# Groundwater Application Review Summary Form

Application # G- 18840

GW Reviewer Travis Brown Date Review Completed: 8/28/2019

TO: Water Rights Section Date 8/28/2019  
 FROM: Groundwater Section Travis Brown  
Reviewer's Name  
 SUBJECT: Application G- 18840 Supersedes review of \_\_\_\_\_  
Date of Review(s)

### Theis Drawdown Analysis

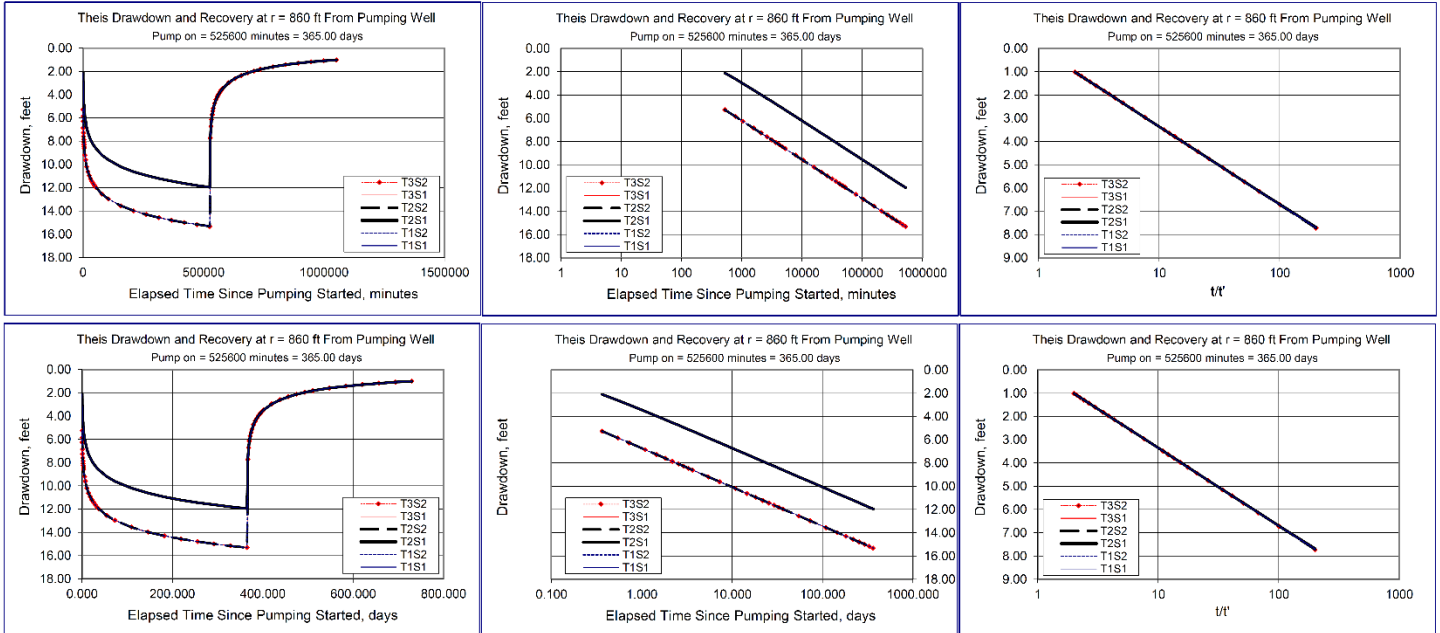
The nearest senior groundwater right producing from similar water-bearing zones as the proposed POA is MARI 143, authorized POA for Certificate 42114. MARI 143 is ~860 ft east of proposed POA 5. To assess the potential for injury to Certificate 42114 due to the proposed use, an analysis was conducted using the Theis (1935) equation for drawdown in a confined aquifer. Hydraulic parameters used for the analysis were derived from regional data and studies (Pumping Test Reports, Conlon et al., 2003, 2005; Iverson, 2002; McFarland and Morgan, 1996; Woodward et al., 1998) or are within a typical range of values for the given parameter within the hydrogeologic regime (Freeze and Cherry, 1979; Domenico and Mifflin, 1965). The applicant has noted in the Application that they have also submitted a Groundwater Registration Modification application (GR-MOD T-13221) which proposes to change the POA for Groundwater Registration GR-3351 to POA 1-5 as identified in this application. Per proposed GR-MOD T-13221, POA 1-5 would pump up to 0.25 cfs under GR-3351, in addition to the 0.45 cfs requested in this application. Therefore, the analysis used a combined rate of 0.7 cfs (~314 gpm) to assess potential injury to nearby senior users. **Results indicate that the proposed use is not likely to interfere with MARI 143 such that a senior groundwater user would be prevented from receiving water to which they are legally entitled (see Theis Drawdown Analysis, attached).**

### Hydrograph - Spring

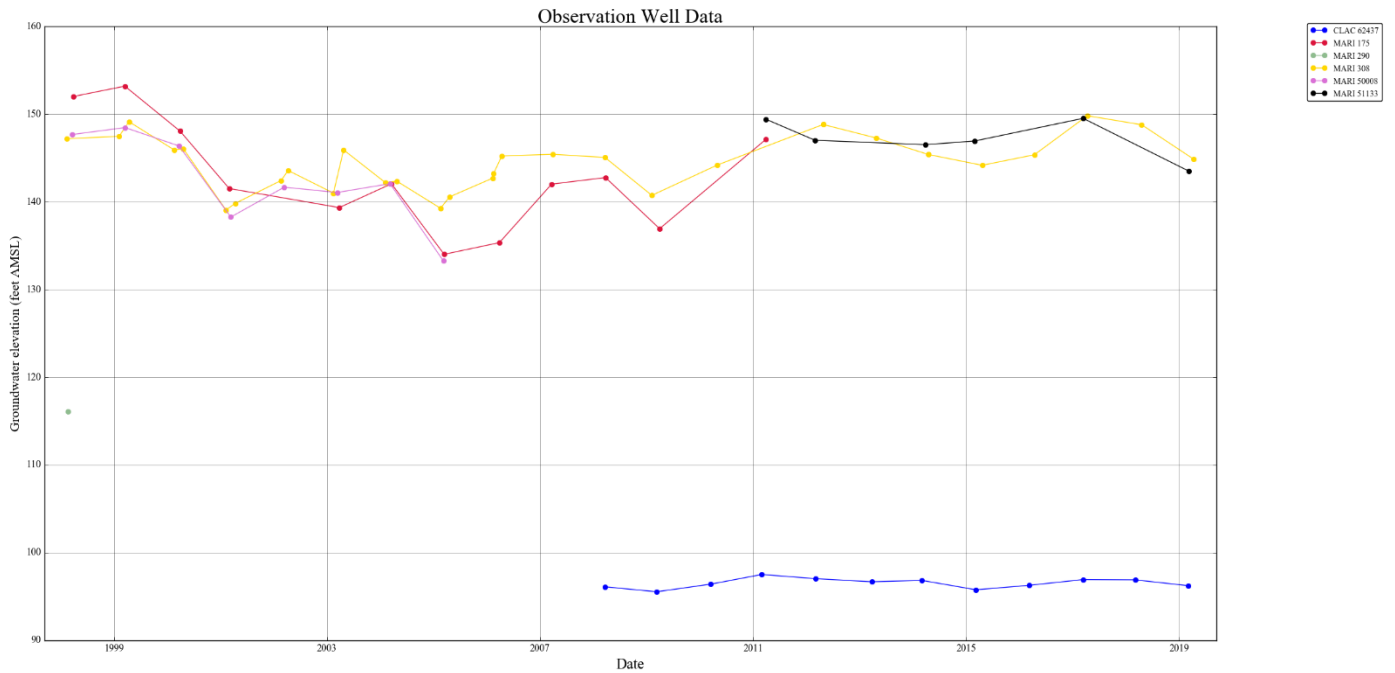
Hydrographs of water levels in the nearby alluvial aquifer system over the past two decades do not indicate widespread or persistent declines (see Hydrograph - Spring, attached). However, there do appear to be substantial (~30 ft or more) seasonal

### Hydrograph – MARI 308

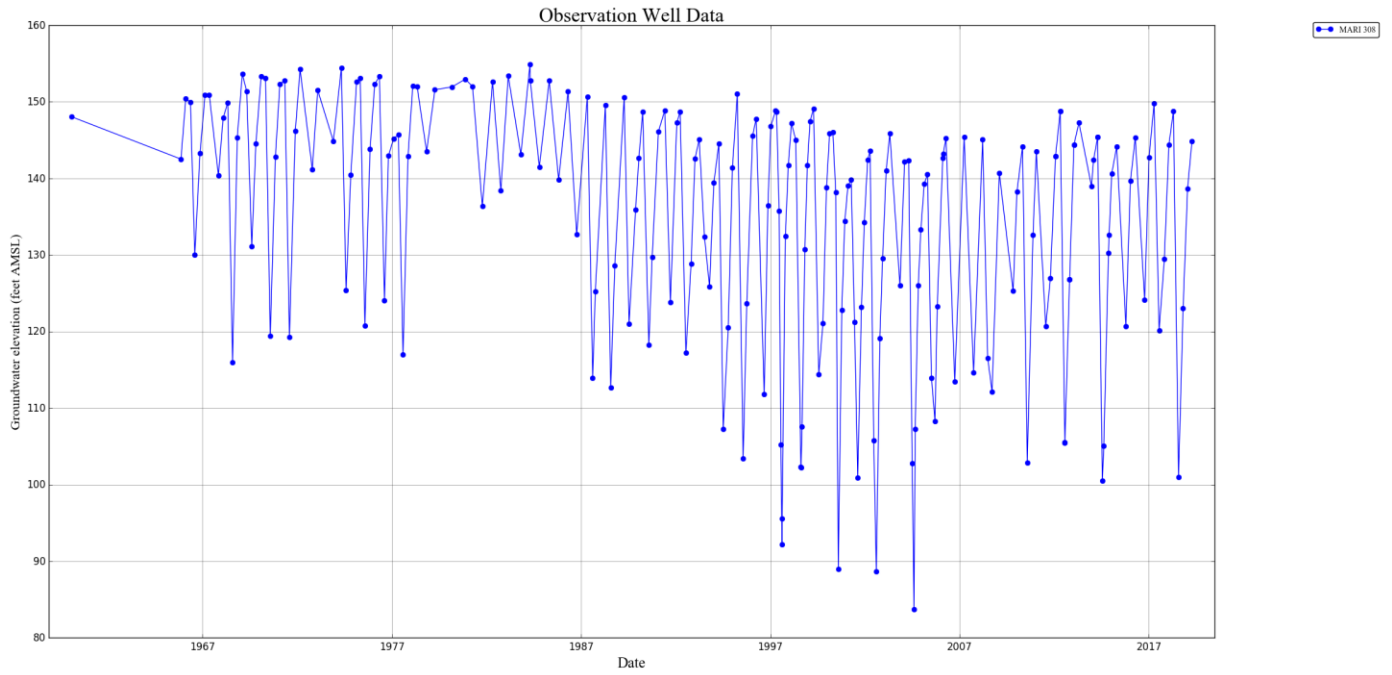
fluctuations in water level based on observations from a nearby State Observation Well (see Hydrograph – MARI 308, attached). Additionally, well completion statistics from the area indicate slight trends of deeper well completions and lower initial reported static water levels over time (see Well Completion Statistics, attached). **While there is not sufficient evidence to conclude that the proposed use would exceed the capacity of the resource, the Conditions specified in B1(d) and B2(c) are recommended to protect the resource and nearby senior users.**

### Well Completion Statistics – 3S/1W-32 & 33, 4S/1W-3 & 4

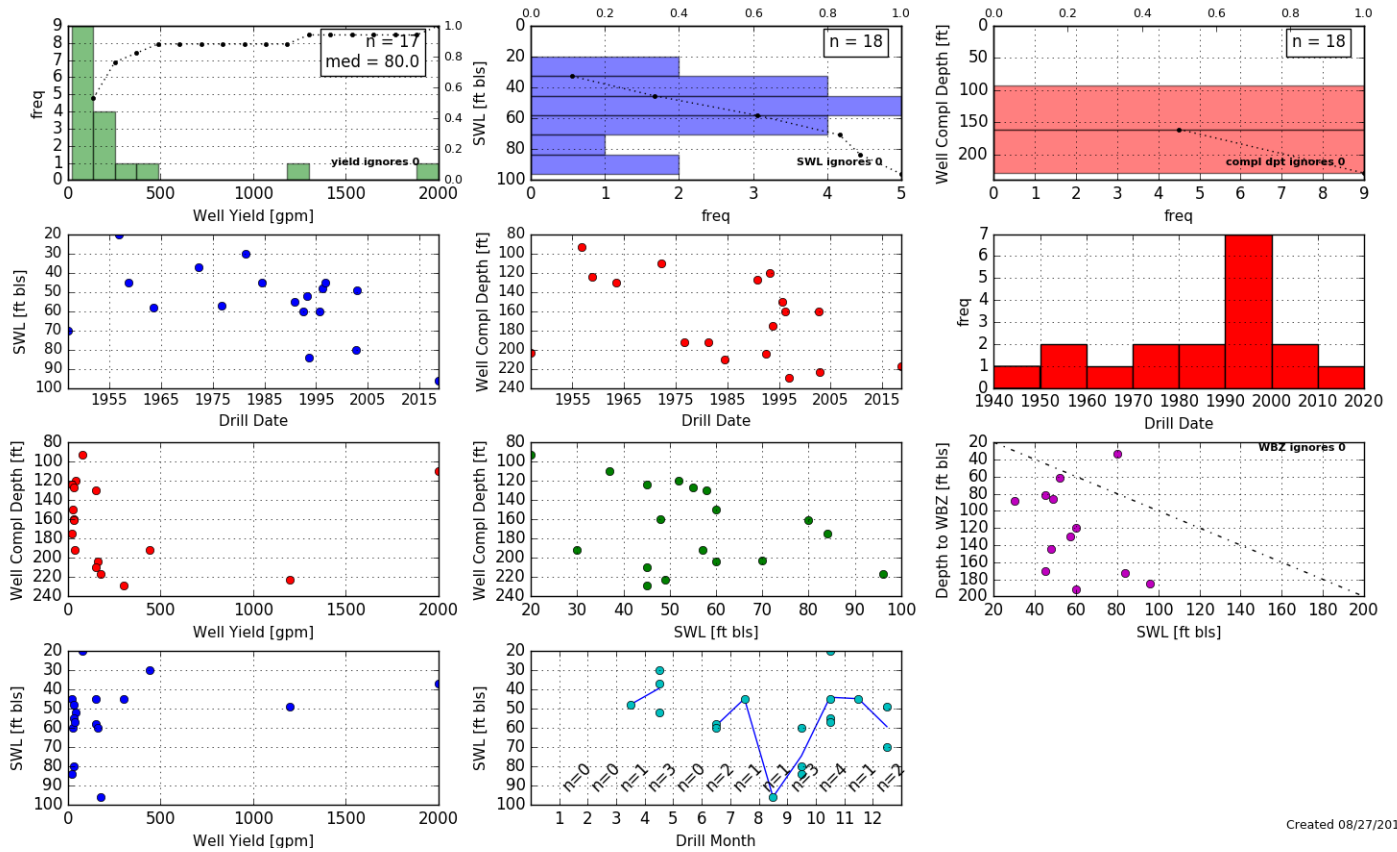
**Basis for aquifer confinement evaluation:** Reported static water level in MARI 68155 was greater than 80 ft above the noted water-bearing zone, indicating confined conditions. Well completion statistics from this area indicate that most completed wells have initial reported static water levels above the first noted water-bearing zone, also indicating confined conditions (see Well Completion Statistics, attached). Based on the available evidence, the aquifer appears to be confined in this area.

**Stream Depletion Analysis – SW 1 (Willamette River)**

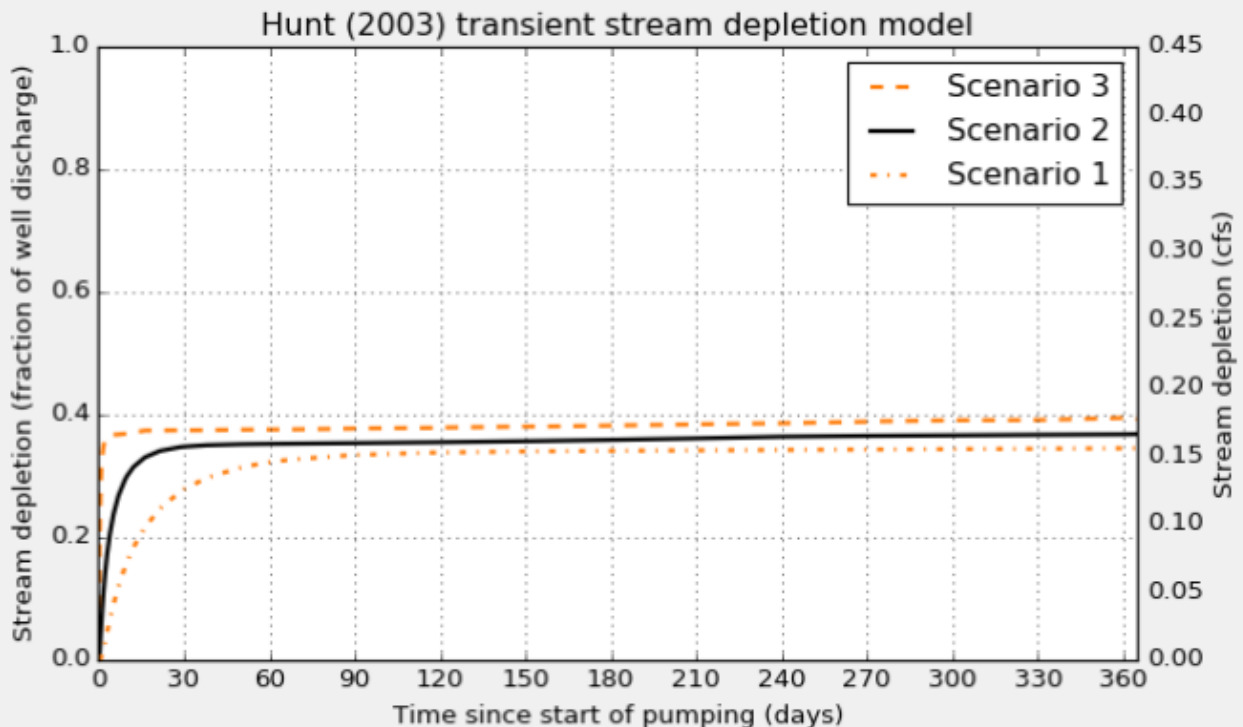
**Comments: 3a:** To assess the potential interference with surface water due to the proposed use, a stream depletion analysis was conducted using the Hunt (2003) analytical model. Hydraulic parameters used for the analysis were derived from regional data and studies (Pumping Test Reports, Conlon et al., 2003, 2005; Iverson, 2002; McFarland and Morgan, 1996; Woodward et al., 1998) or are within a typical range of values for the given parameter within the hydrogeologic regime (Freeze and Cherry, 1979; Domenico and Mifflin, 1965). Results of the analysis indicate that the proposed use will primarily impact SW 1 (Willamette River), with depletions of SW 1 most likely exceeding 25 percent of the rate of well discharge within 30 days of continuous use (see Stream Depletion Analysis, attached). The high relative rate of stream depletion is attributed primarily to the small intervening thickness of fine-grained sediments between the alluvial aquifer system and SW 1 (Willamette River) (i.e. a highly efficient hydraulic connection) and the confined nature of the alluvial aquifer. **Per OAR 690-009-0040(4)(d), the proposed use is assumed to have the potential to cause substantial interference (PSI) with SW 1 (Willamette River).**

Additionally, the maximum rate of withdrawal under the proposed use (0.45 cfs) is greater than 1 percent (0.0188 cfs) of the natural streamflow that is equaled or exceeded 80 percent of time (1.88 cfs) for SW 2 (Deer Creek). **Per OAR 690-009-0040(4)(c), the proposed use is assumed to have PSI with SW 2 (Deer Creek).**
